Manual Supplement

Manual Title: 8922A
Part Number: 522052
Print Date: June 1979
Revision/Date:

Supplement Issue: 7
Issue Date: 1/96
Page Count: 10

On page 603-2, replace Figure 603-1 with:

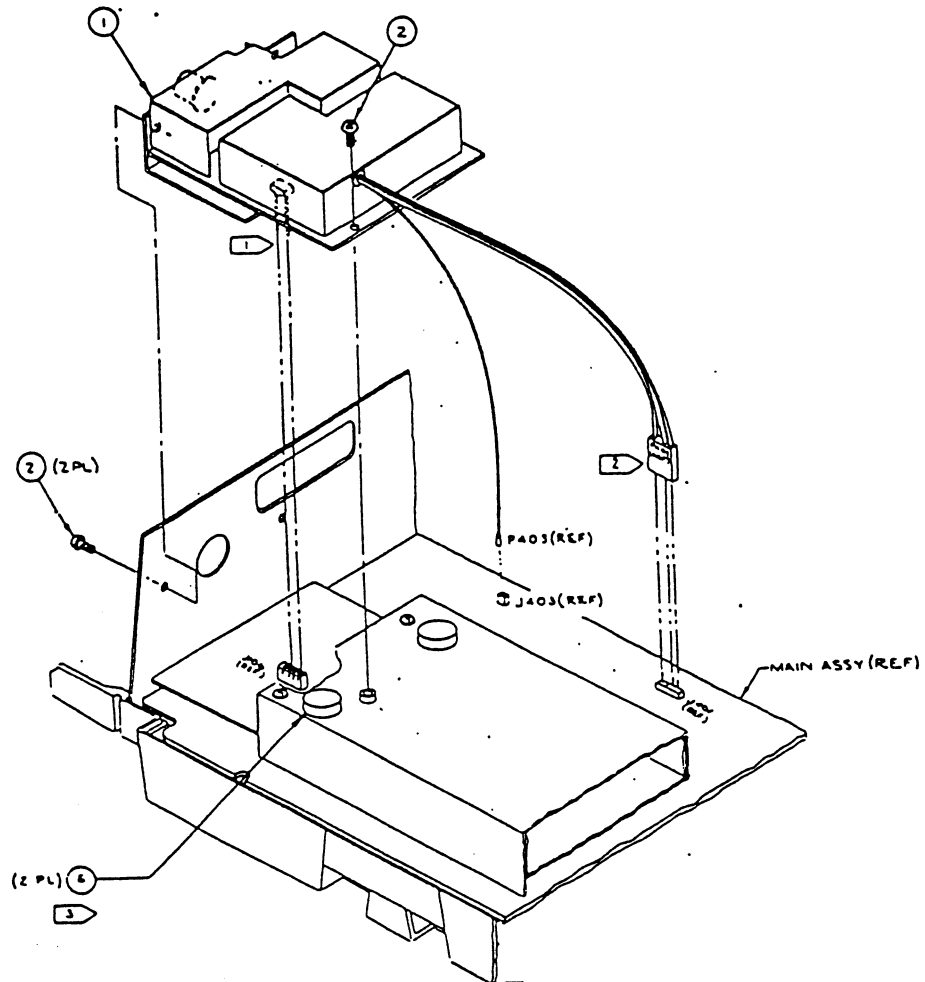
On page 603-1, paragraph 603-6, add new steps 4 and 5 as follows, and renumber old steps 4 and 5 as step 6 and 7.

4. Connect ground wire (P403) to J403 on the A1 Main PCB Assembly.
5. Place the rubber foot on the AC shield near the screws as shown in Figure 603-1.

8920A-1615
Active Load

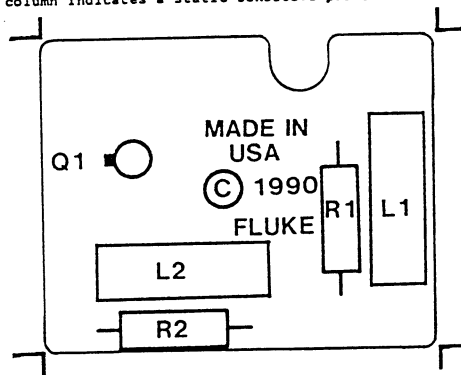
ADD: A2A1IASSY,ACTIVE LOADI885442I89536I885442I1

After page 5-18, add the following:

**8920A-1015
Active Load**

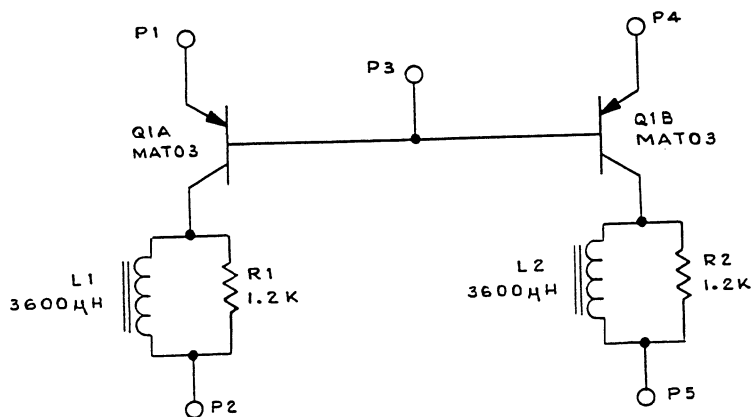
After page 8-8, Figure 8-3, add the following:
